Expert Evidence
(Groundwater)
North East Link
Project Environment
Effects Statement
(EES)

Prepared for:
Manningham City Council
Banyule City Council
Boroondara City Council
Whitehorse City Council

Prepared by:
Christopher Smitt

July 2019

Figure 4-1 Melbourne Water Data for Bolin Bolin Billabong

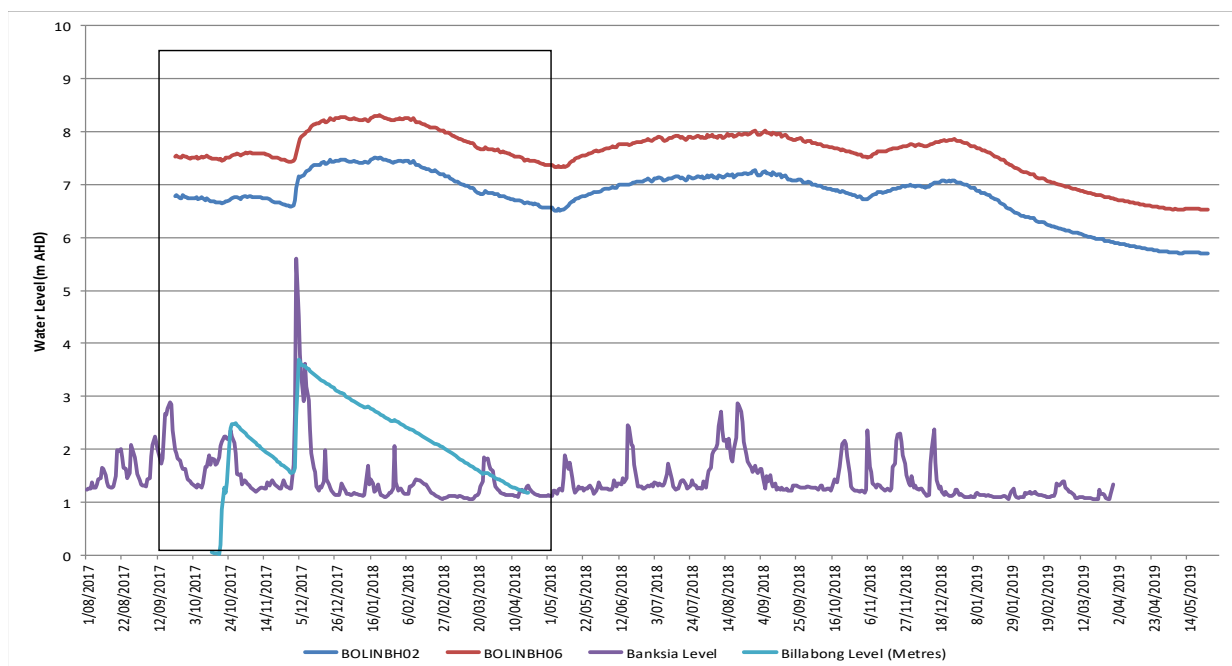
The only dataset that was obtained for review was supplied from Melbourne Water. This is graphically shown in **Figure 4-1**. The chain of communication and data can be provided on request. When comparing this dataset with that presented in EES Technical Report N, errors were immediately discovered. I believe the data supplied from Melbourne Water to be correct, meaning I do not believe the data shown in Figure 6-9 on Page 80 of EES Technical Report N, (reproduced as **Figure 4-2**).

The error was identified when reviewing Figure 6-9 on Page 80 of EES Technical Report N (reproduced as **Figure 4-2**). This figure depicts surface water and groundwater levels in the vicinity of Bolin Bolin Billabong between August 2017 and May 2018.

The data within the black box on **Figure 4-1** represents the same time period as the data represented on **Figure 4-2**. As can be clearly seen, groundwater elevations monitored within BH02 and BH06 do not match. **Figure 4-2** (i.e. Figure 6-9 of EES Technical Report N) suggests that groundwater levels are found between 1.5 and 6 metres Australian Height Datum (mAHD), however the data provided directly by Melbourne Water (refer **Figure 4-1**) indicates water levels are much higher and fluctuates between 6.5 and 8.2 mAHD for the same corresponding period. For Bore BH06, this difference can be up to 6.7 metres (m) with Figure 6-9 of EES Technical Report N placing the depth to groundwater several metres below the Yarra River invert. This conceptually is wrong.

Figure 4-3 Conceptualisation of Bolin Bolin Billabong (taken from page 98; EES Technical Report N)

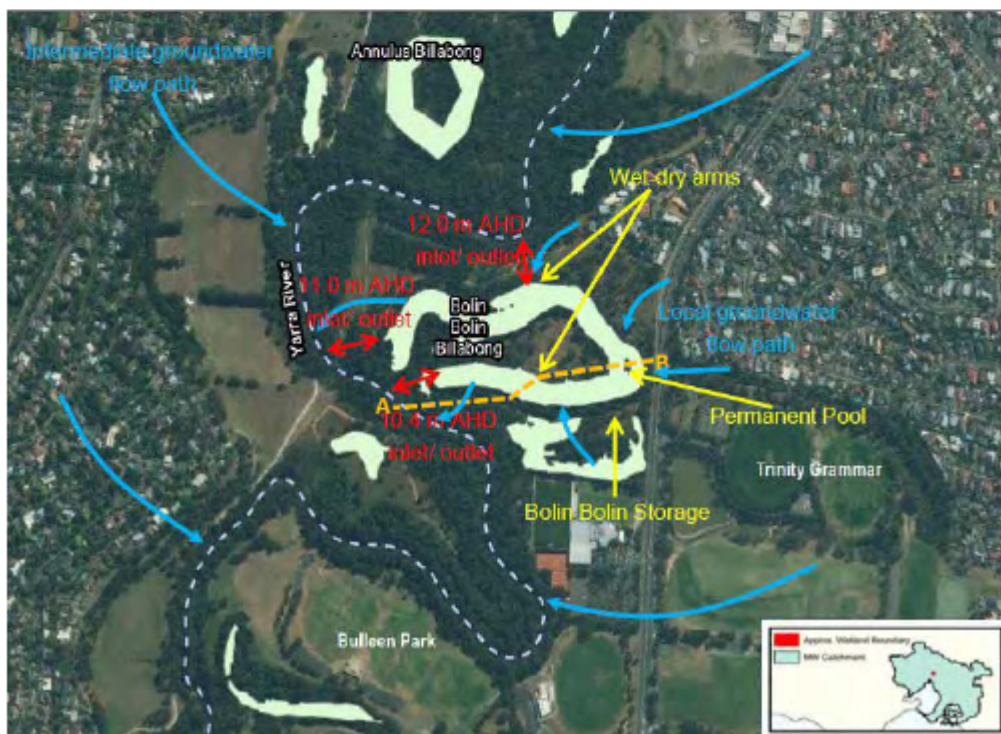
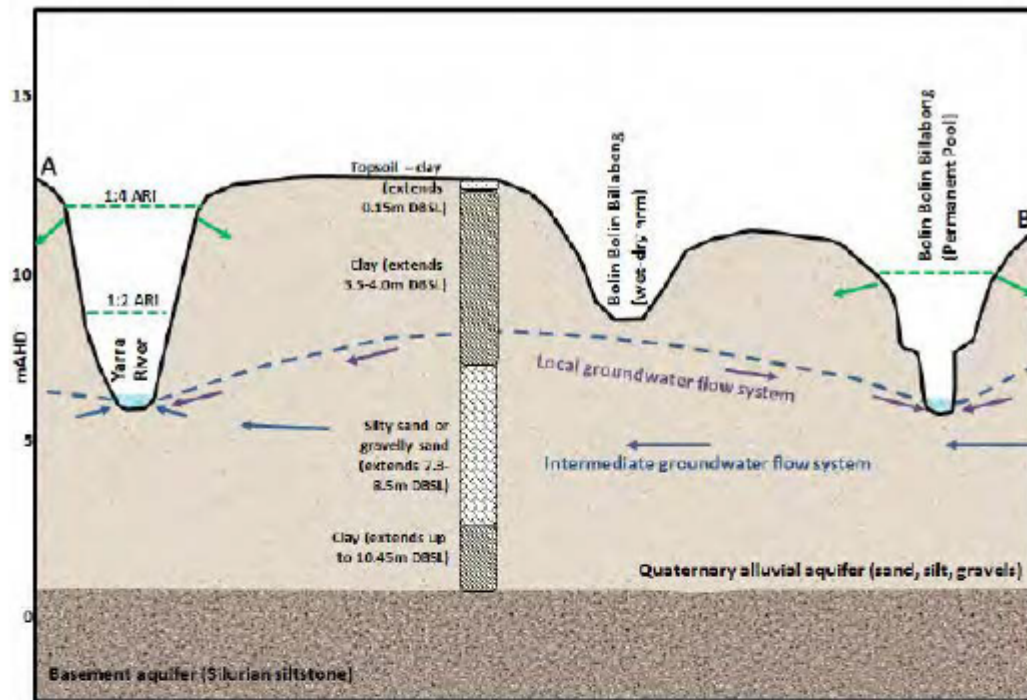
As Bolin Bolin Billabong (shown in cross section on **Figure 4-3**) is regarded as a high value ox-bow lake, the ramification of using or reporting incorrect data can be serious. For example, model predictions or setting design environmental performance requirements (EPRs) to protect/maintain the ecosystem could be wrong. It also raises concerns over the quality assurance (QA) and quality checking (QC) process that has (or has not) been undertaken.

As shown on EES Technical Report N Figure 6-16 (reproduced in **Figure 4-3**), the standing water level is approximately 5 m below ground level and the bore has a depth of 10 m. Therefore, the **available drawdown** is 5 m (not 10 m as implied in EES Technical Report N). This means that a 0.5 m drop in water level results in a 10 percent loss of available drawdown. Considering uncertainty and the precautionary principle, this is an unacceptable drawdown.

All of these scenarios show that its entirely possible for a particle of water (and potentially contaminated water) to migrate in either the bedrock or alluvium (the 2 aquifers present) in less than the construction period where dewatering would be occurring (estimated between 2 and 5 years). Therefore, the identification of all (and potential) known sources of contamination (which is acknowledged to be lacking, refer **Appendix C**), needs to be thoroughly risk assessed as the proposed EPR's have been developed based on incorrect data.

Figure 4-4 Conceptualisation and Part Water Balance of Bolin Bolin Billabong (Analytical Calculations by C Smitt)

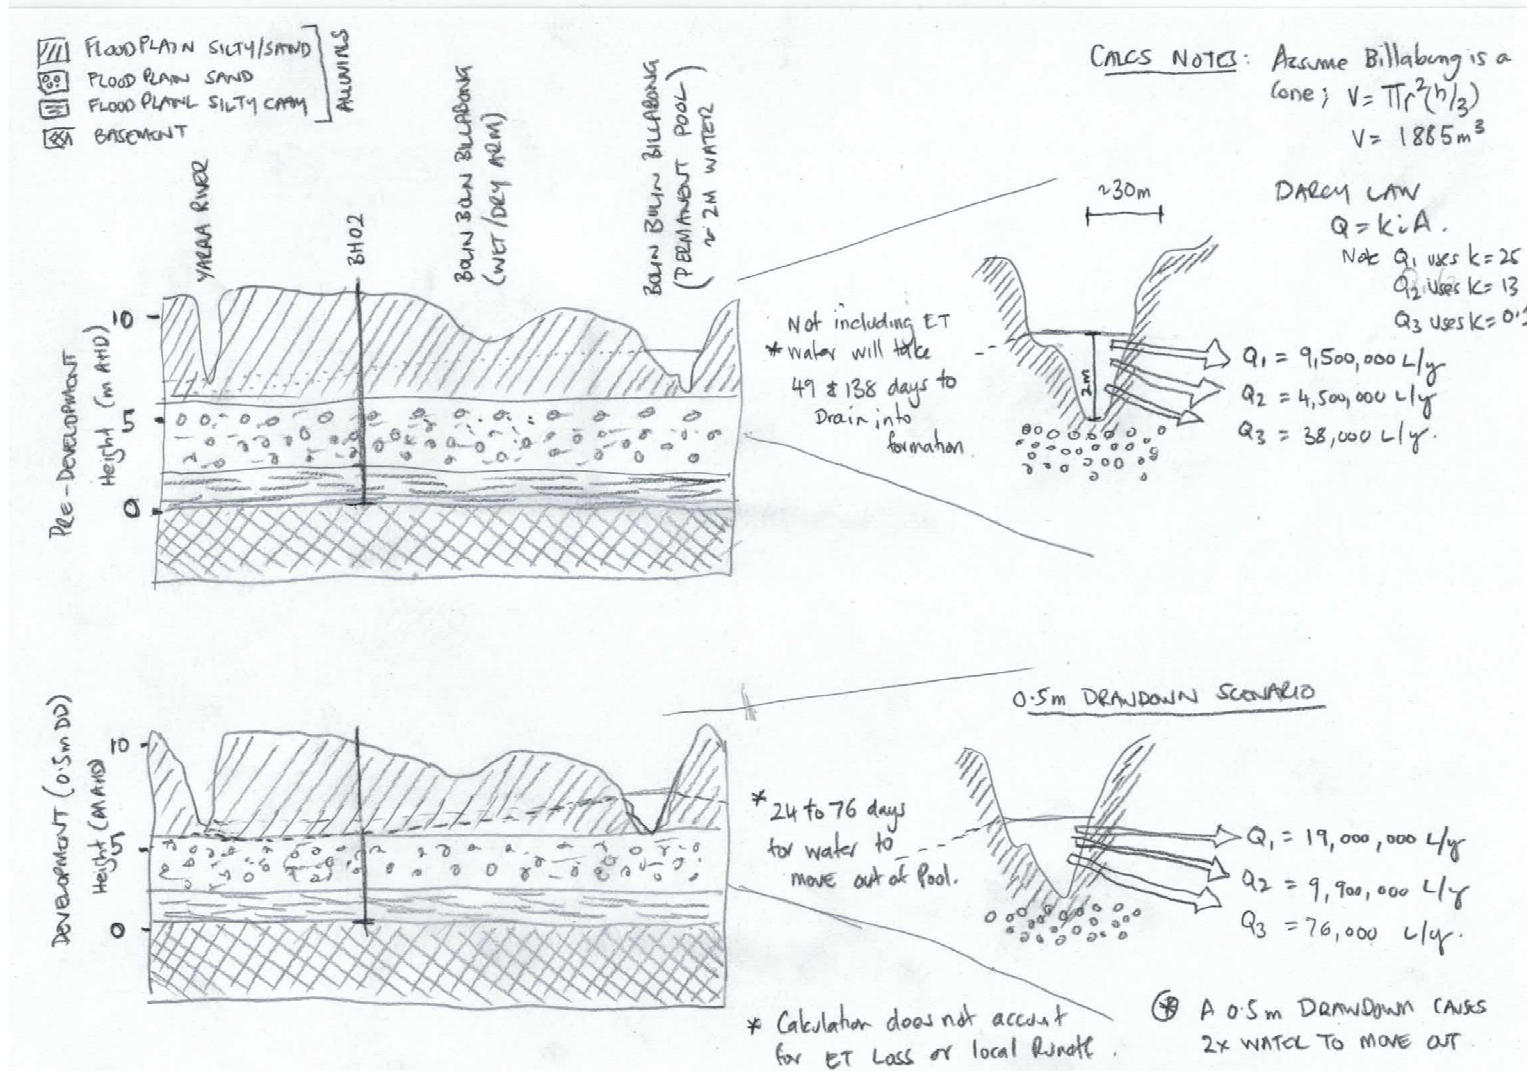
In addition to the potential error or mis-representation of this data, in the vicinity of this location, the groundwater model predicts up to 0.5 m of drawdown to occur (refer page 44 [Figure 26], Appendix C of EES Technical Report N). If adequate QA/QC processes have not been adopted, this value could be much larger. Nevertheless, the significance of what a 0.5m drawdown may mean is visualised and quantified on **Figure 4-4**. This figure adopts the conceptualisation shown in **Figure 4-3**

Assuming the water levels provided by Melbourne Water are correct, I have calculated the groundwater flux from the permanent pool in to the aquifer based on the following:

Figure 4-5 Calibrated Hydrographs (modified from Figure 18, Page 32, Appendix C of EES Technical Report N). Graphs highlighted by a red box demonstrate poor calibration (i.e. model prediction not well aligned to real world data).

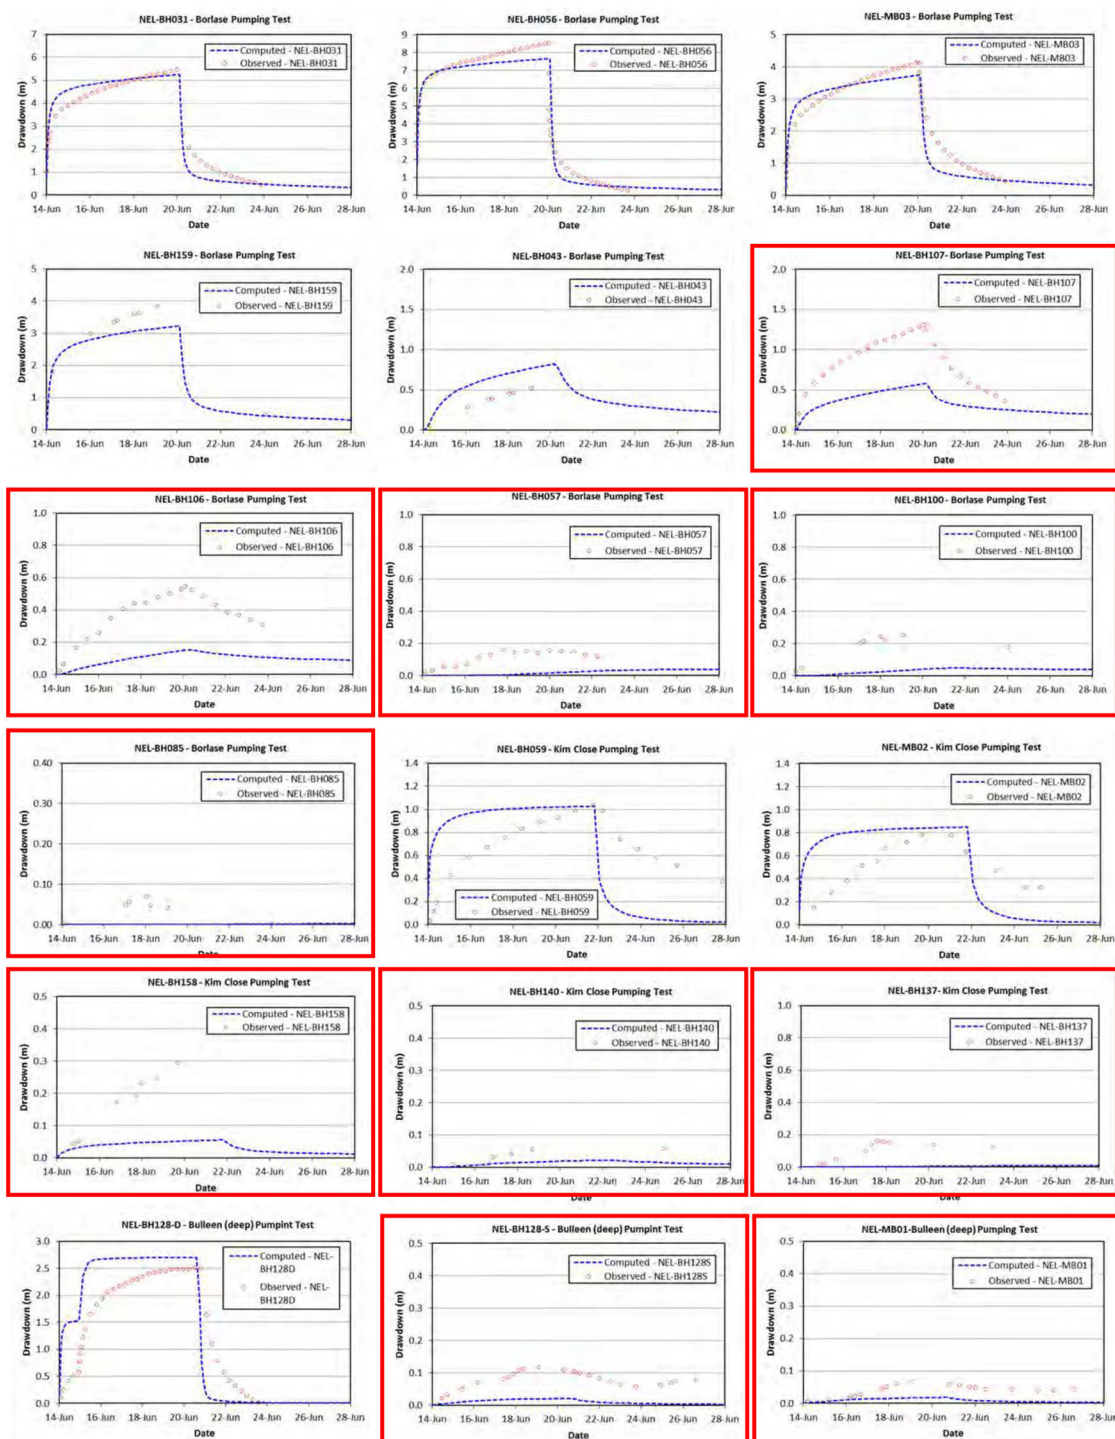
- Recharge (i.e. rainfall that infiltrates in to an aquifer) is only calibrated in steady state. This means seasonal fluctuations as a result of recharge cannot be rigorously assessed through calibration to existing data.
- Calibration statistics claims of scaled root mean square (SRMS) error of less than 10 percent (i.e. numerical difference between model outputs and observed data) with respect to hydraulic heads or mass balance error of less than 1 percent are easily obtained when the model has only a few datapoints to calibrate against.
- The calibrated hydrographs presented on Figure 18 (Appendix C of EES Technical Report N) and reproduced in **Figure 4-5**, show a relatively poor fit in most bores that had a pump test performed.

Whilst the calibration process used “PEST” (a useful and popular software to automate parameter estimation), this initial data input was limited and consisted of steady state calibration using few data points (i.e. April 2018 groundwater levels [heads]), followed by transient calibration to drawdown observed during pumping tests. The result of which often showed poor fit in environmentally sensitive areas. This is shown in **Figure 4-5** where up to ~1m (at NEL-BH107) or 300% (at NEH-BN106) difference between model performance and real-world test are observed.

Therefore, whilst the model may be fit for purpose to initially inform hydrogeological design parameters for the use of TBMs etc., applying the “calibrated” K to floodplains and billabongs/swamps associated within waterways (i.e. areas where sensitive environmental receptors are found) may not reflect the true hydro-dynamics within these areas. In fact, a high K (which I believe has been used), will often dampen any potential impacts. As presented earlier (refer **Figure 4-4**), if the predictions are only out by 0.5m, this can conservatively equate to an increase in leakage of ~5,000,000 L (every year) for the permanent pool at the Bolin Bolin Billabong.
